Document Description : Addendum No. 1 Cass SP Group 1 Company House Rehabilitation

**ADDENDUM NO. 01
REQUEST FOR QUOTATION
West Virginia Division of Natural Resources-Parks & Recreation
ARFQ-0310-DNR19*61 Cass SP Group 1 Company House Rehabilitation and Renovation**

RESPONSE TO VENDOR QUESTIONS

PROJECT SCOPE OF WORK
COMPANY HOUSE #253

Bathroom renovations spec.

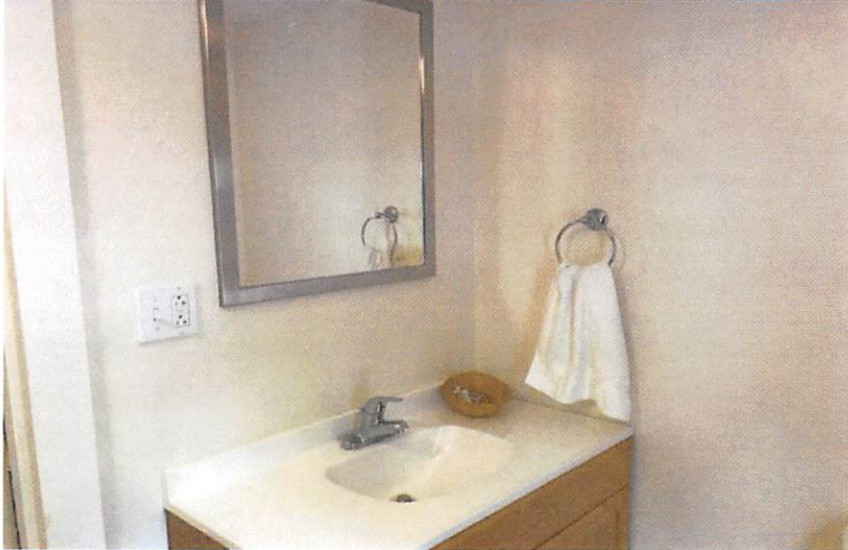
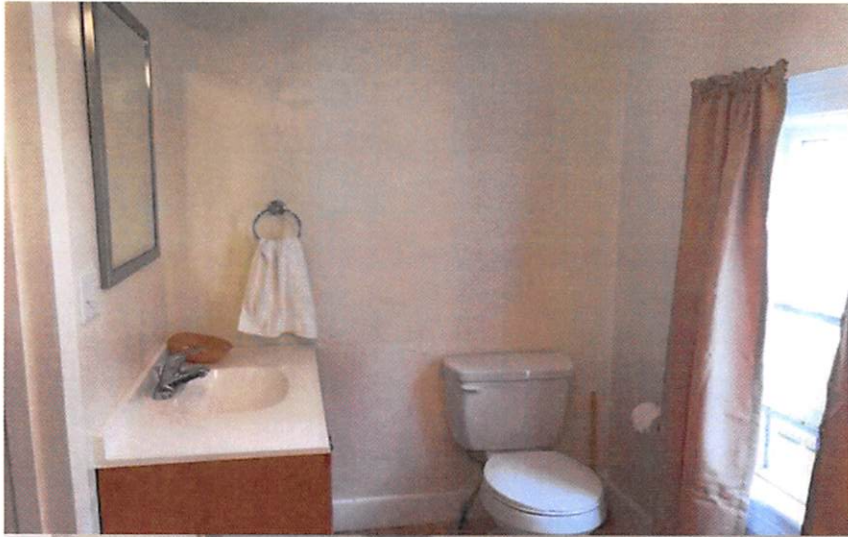
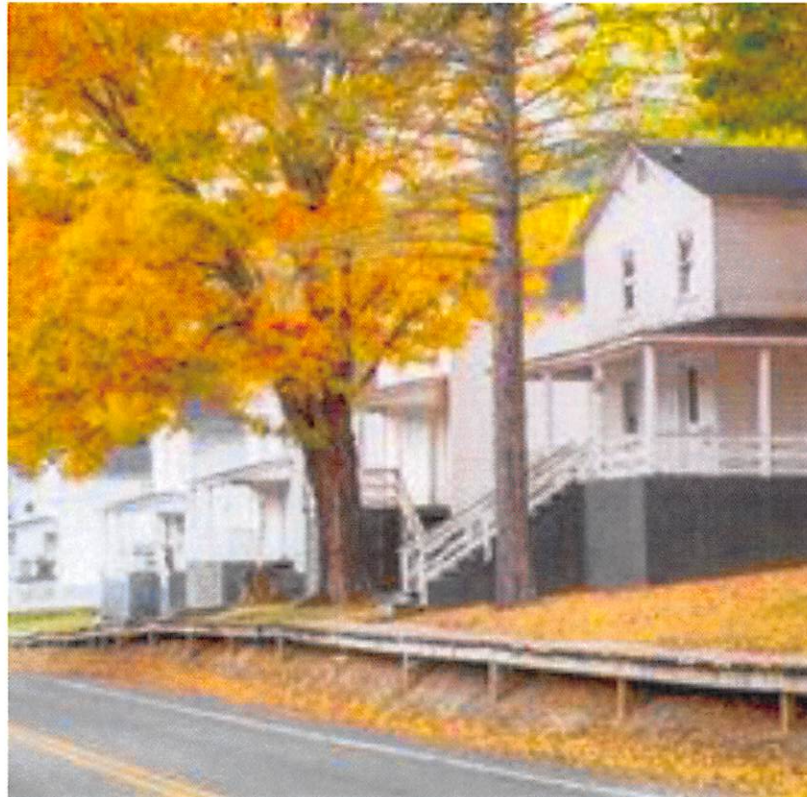
The last note in the “Project Scope of Work Section-Bathroom Structure” states, “Vendor must orient bathroom as per new configurations (see attachment).” This note is typical for all company houses in all 3 projects. There have been no attachments provided with the RFQ. Can you please provide the attachment with details on reconfiguring the bathroom?

Bathroom renovations in all houses are similar. A drawing of the lay out of the bathroom renovation is pictured to the left. The next slide has an example of one of the bathrooms we have completed on the park with the same specs required in this bid project. House 242 and 139 will be available for viewing today to see what expectations will be concerning bathroom renovations. This includes all bathroom renovations with the exception of 262. and 253. In 262 and 253 the orientation of the bathroom is the same, but no additional room is needed from adjacent bedroom.

Company House 253
Remove bath-tub and Closet

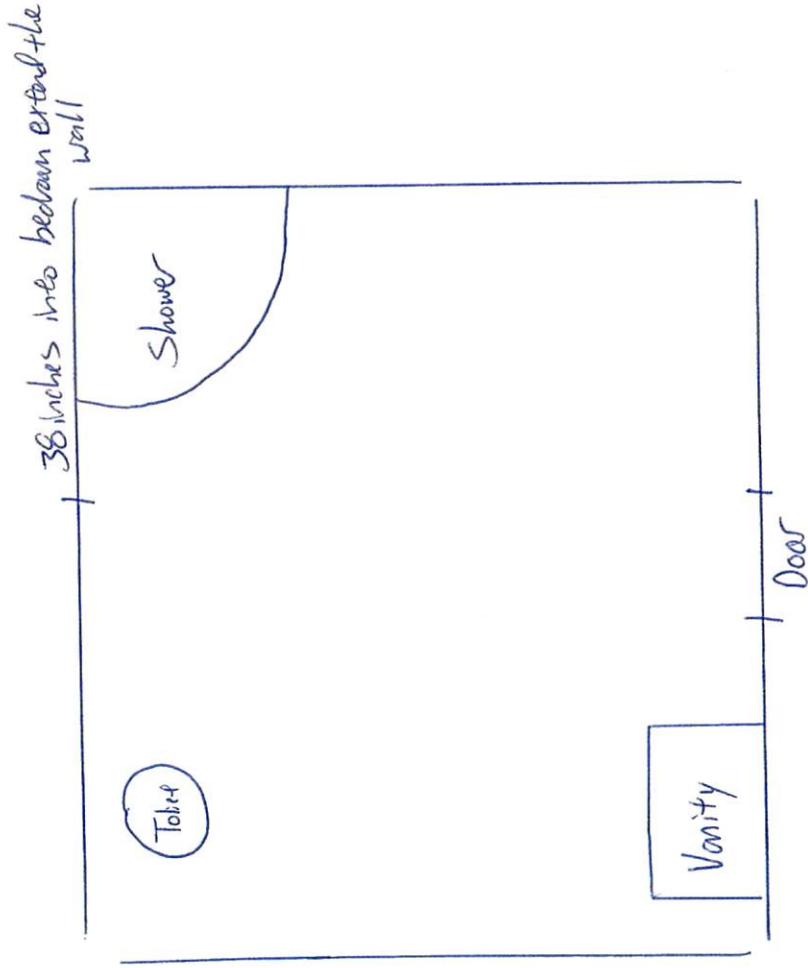
16.3.2 Vendor must remove closet/access in closet, and existing shower.

Company House 253
Bathroom

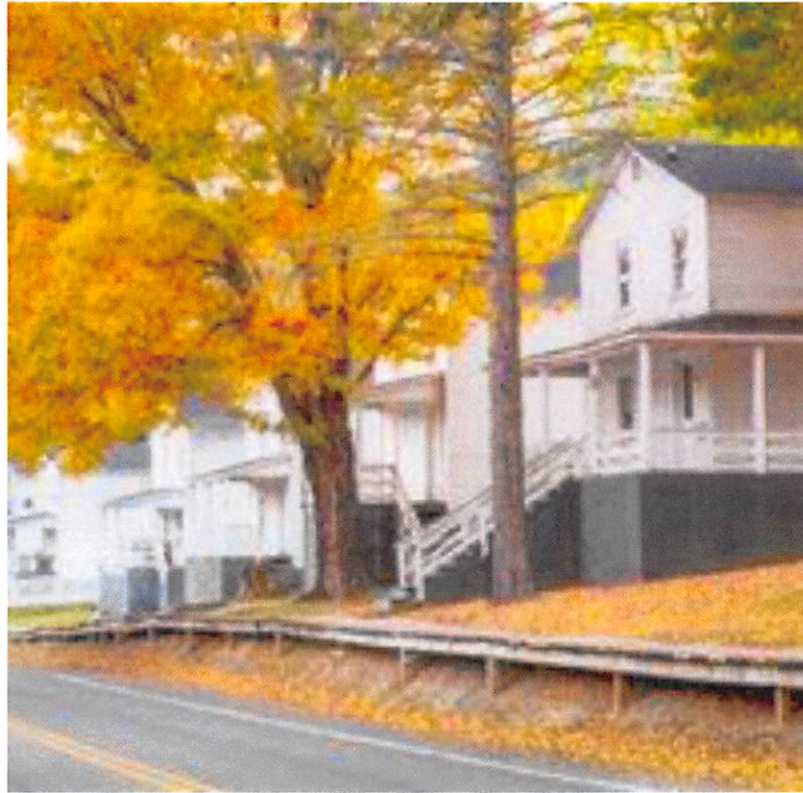
16.3.1 Vendor must remove wall and extend bathroom 38 inches into adjacent bedroom, Walls should be standard 2"x 4", studs at 24" centers;

16.3.10 Vendor must orient bathroom as per new configurations (see attachment);

Company House 262 Bathroom only

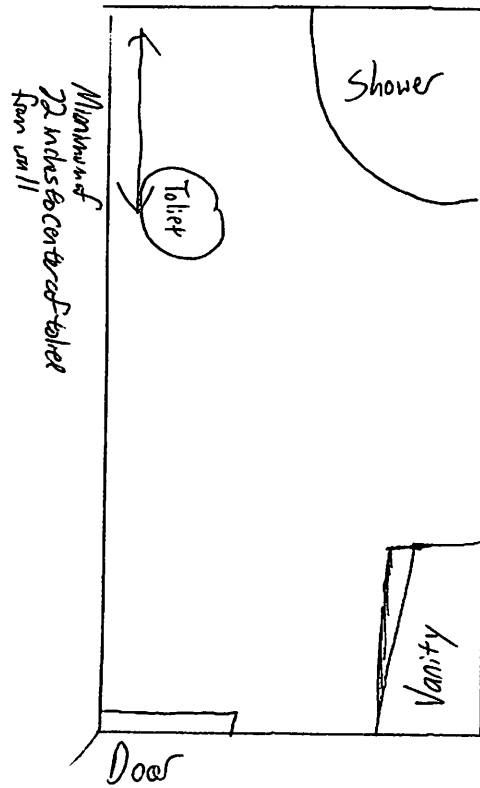
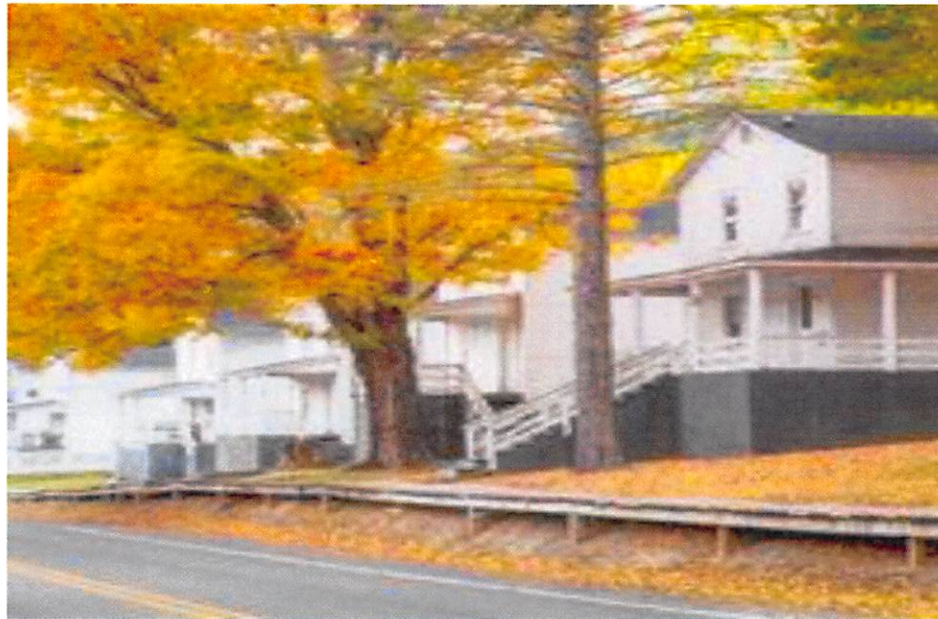
No bathroom Extension
with this unit

Remove shower
Leave the heater
